**CONSENT TO PROCEED
AND
FIRST AMENDMENT
TO
COST REIMBURSEMENT AGREEMENT**

Dated as of September ¹⁴~~30~~, 2015
(the "Amendment Effective Date")

**REVISED PRELIMINARY ENGINEERING REPORT FOR
NATIONAL GRID WORK TO SUPPORT MSSC PROJECT**

August 12, 2015

IA. Edic Station REVISED and Updated Scope (see Reference Drawing # Drawing # D-66895-C, sht 1)

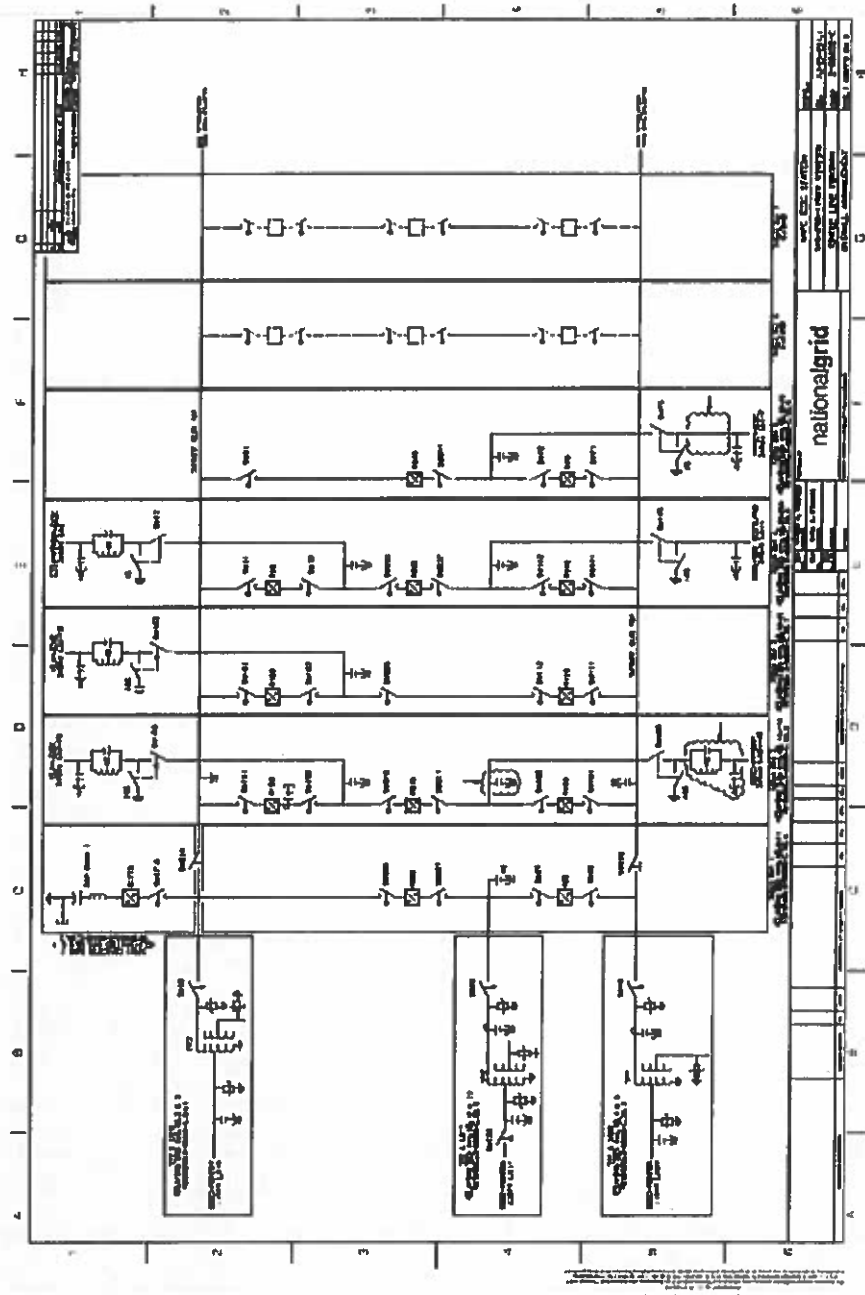
1. Due to NPCC Bulk Power separation criteria and the overcrowded conditions existing in the Edic control building, the new protective relays and telecommunications equipment for MSSC/TOTS must be installed in a new control building that will be constructed by National Grid. Evaluation of site conditions has led to a determination that the upgrades cannot be performed using outdoor panels or cabinets while still meeting Bulk Power System (BPS) separation criteria.
2. The Edic-Fraser Line 24-40 protective relays and telecommunications are being designed as follows:

The A line protection package will be a directional comparison unblocking (DCUB) scheme using a GE D60 and RFL 9780 carrier equipment. Switch onto fault and stub bus protection shall be utilized.

The B line protection package will be a permissive overreaching transfer trip (POTT) scheme using an SEL-421-5 and RFL GARD8000 tone equipment. Switch onto fault protection shall be utilized.
3. The Marcy-Edic Line UE1-7 protective relays and telecommunications are being designed as follows:

The A line protection package will be a line differential SEL-411L. Redundant fiber pairs will be used for communication to Marcy. Switch onto fault and stub bus protection shall be utilized. Backup distance functions will be enabled for backup when both differential channels are lost.

The B line protection package will be a line differential SEL-311L. Redundant fiber pairs will be used for communication to Marcy. Switch onto fault and stub bus protection shall be utilized. Backup distance functions will be enabled for backup when both differential channels are lost.

A redundant direct transfer trip scheme for breaker failure at Marcy will be used. The A and B packages will use mirrored bits on fiber using SEL-351 relays. The schemes will trip the breakers and drive the reclosing relay to lockout.

The new, second fiber optic channel from Marcy (SkyWrap to be installed by Others for NYPA) will require the fiber pairs to be directed from the NYPA splice box at the Edic switchyard entry to the Edic control building, and terminated / patched by National Grid to the relay panels in order to complete the fiber path.

4. The Edic-New Scotland Line 14 protective relays and telecommunications are being designed as follows:

The A line protection package will be a permissive overreaching transfer trip (POTT) scheme using a GE D60 and RFL IMUX 2000 multiplexer with DS-TT cards.

The B line protection package will be a directional comparison unblocking (DCUB) scheme using an SEL-421-5 and RFL IMUX 2000 multiplexer with DS-TT cards.

5. The Edic-Clay Lines 2-15 and 1-16 protective relays have been designed and installed as follows.

The A line protection relay on each line has been replaced with an SEL-421-5 with series compensation settings capabilities. The relays have been programmed and placed in service on 5/27/15.

The existing B line protection relay on each line (ERL Phase LPro-2100) has been reprogrammed with new settings to accommodate the series compensation.

6. Certain cabling and control cabling costs were added not identified in the first version of the preliminary engineering report.

IIA. New Scotland – Updated Scope (see Reference Drawings C-8059-E shts 4,7, 8)

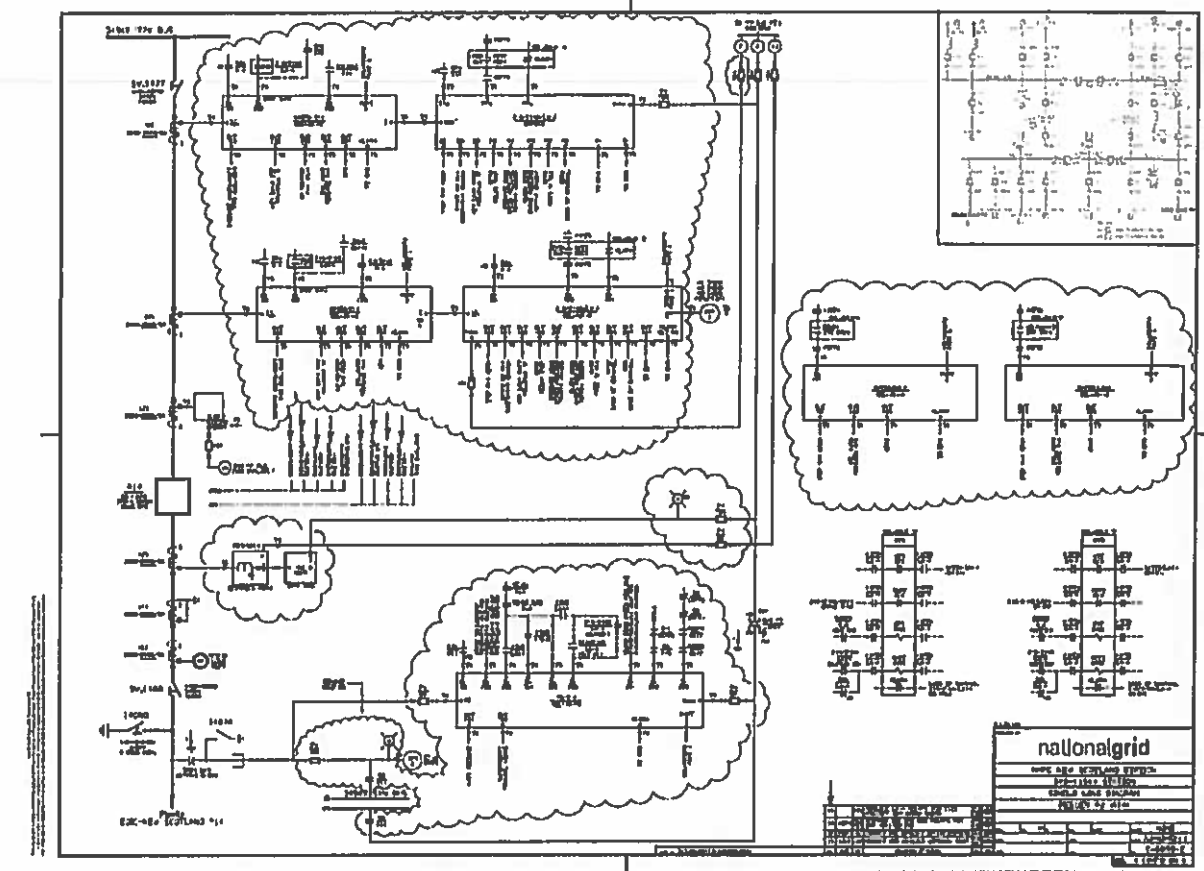
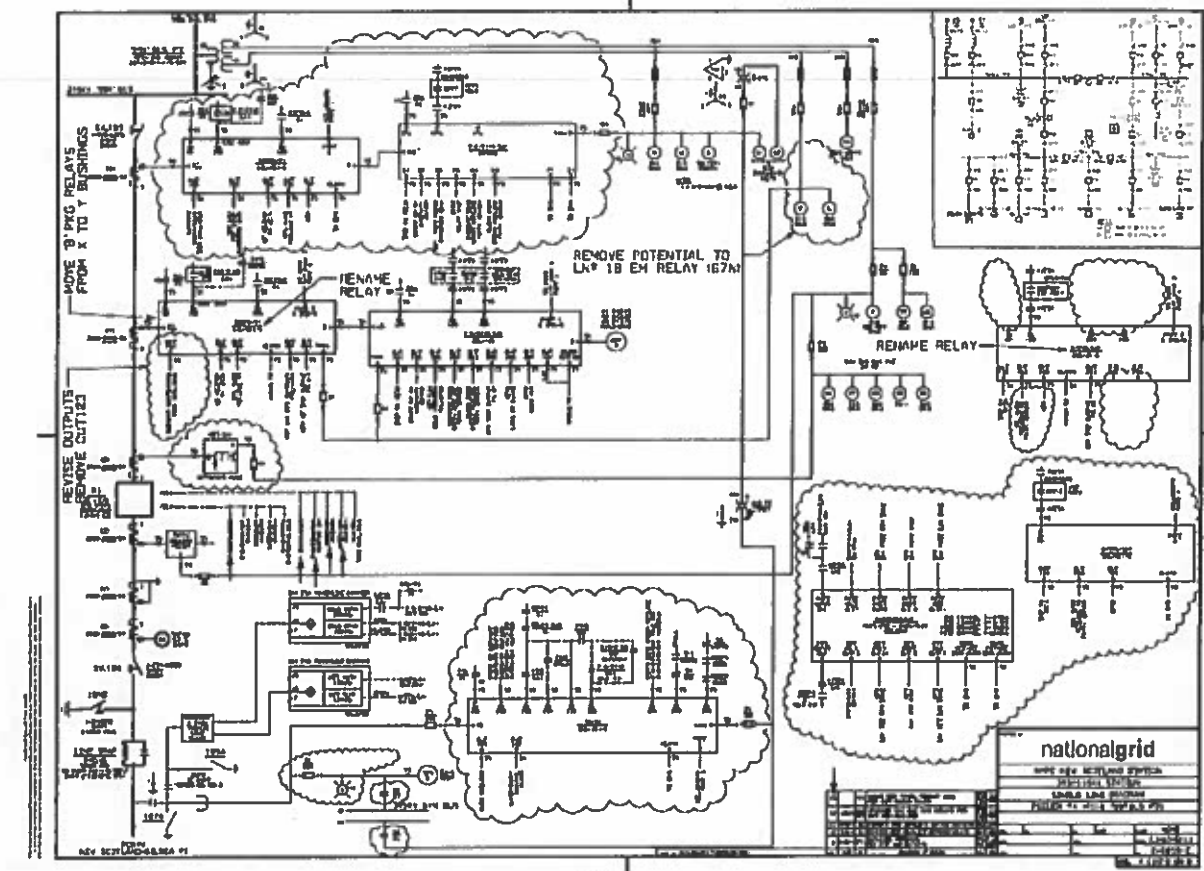
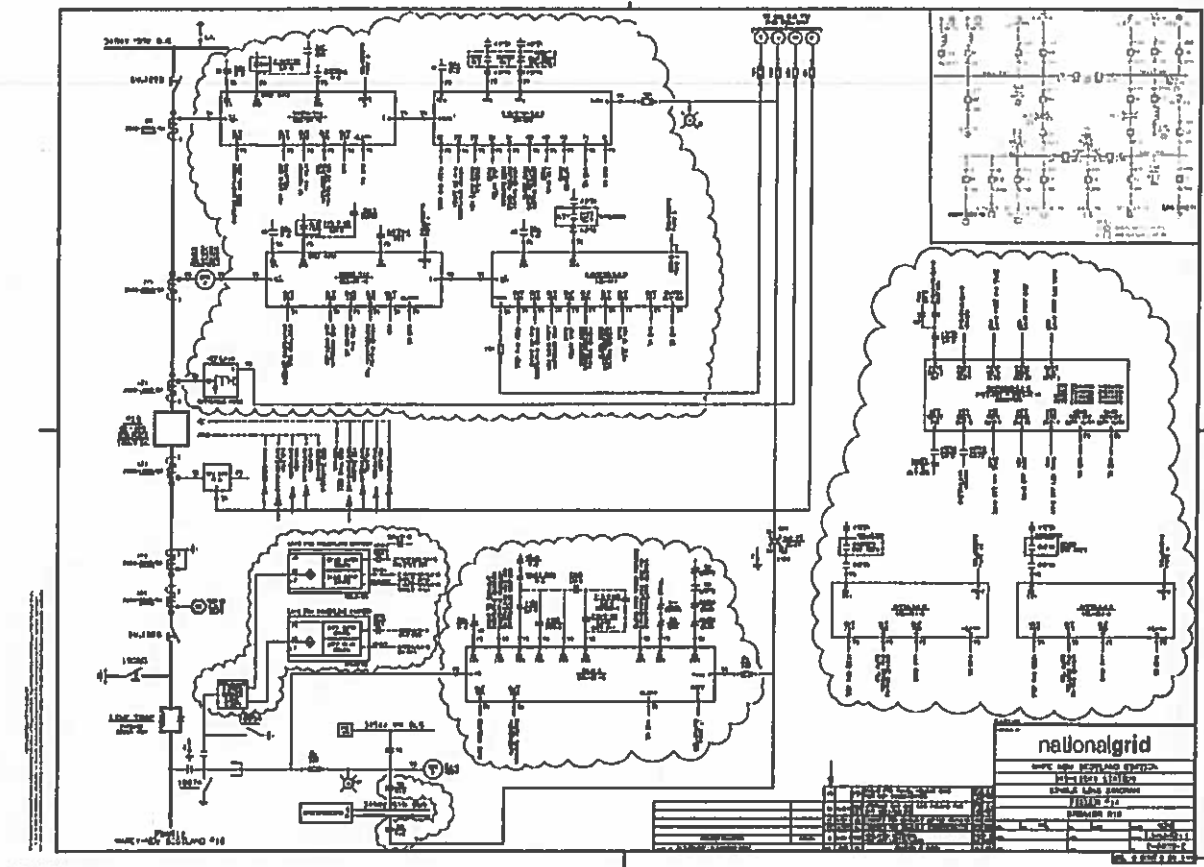
1. The Original Scope assumed that New Scotland Station had proper A and B separation to meet NPCC Bulk Power criteria. During preparation of National Grid's technical scope, it was determined that control buildings 1 and 2 do not have proper separation. Only control building 3 has proper separation. In order to ensure proper separation, it was determined to install all the new relays in control building 3.
2. The Gilboa-New Scotland Line 1 protective relays and telecommunications are being designed as follows:

The A line relay protection package will be a microprocessor-based directional distance relay (GE-D60) in a permissive overreaching (POTT) scheme. An RFL GARD8000 will be used for communication to Gilboa station. The GARD8000 will be programmed to match the RFL9745 installed at Gilboa. A leased line

will be used for the communication medium. This relay and telecommunications package will be installed in control building 3.

The existing B line relay protection will be renamed and re-used, with updated relay settings to accommodate the series compensation. The 21TTB/46TTB/LN1 relay will be renamed to 94TTB/LN1 and all potential and current sources will be disconnected.

3. The Edic-New Scotland Line 14 protective relays and telecommunications are being designed as follows:

To achieve proper A and B separation, the new relays for Line 14 will be installed in control building 3. This will necessitate replacement of both the A and B line protection packages.

The A line relay protection package will be a microprocessor-based directional distance relay (GE D60) in a permissive overreaching (POTT) scheme. A DS-TT card in an RFL IMUX 2000 will be used for communication to Edic station.

The B line relay protection package will be a microprocessor-based directional distance relay (SEL-421-5) configured in a permissive overreaching (POTT) scheme. A DS-TT card in an RFL IMUX 2000 will be used for communication to Edic Station.

4. The Marcy-New Scotland Line 18 protective relays and telecommunications are being designed as follows:

To achieve proper A and B separation, the new relays for Line 18 will be installed in control building 3. This will necessitate replacement of both the A and B line protection packages.

The A line relay protection package will be a microprocessor-based directional distance relay (GE D60) in a directional comparison unblocking (DCUB) scheme. An RFL 9780 FSK power line carrier set will be used for communication to Marcy station.

The B line relay protection package will be a microprocessor-based directional distance relay (SEL-421-5) configured in a permissive overreaching transfer trip (POTT) scheme. An RFL GARD8000 will be used for communication to Marcy station. The GARD8000 will be programmed to match the RFL9745 installed at Marcy. A leased phone line will be used for the communication medium.
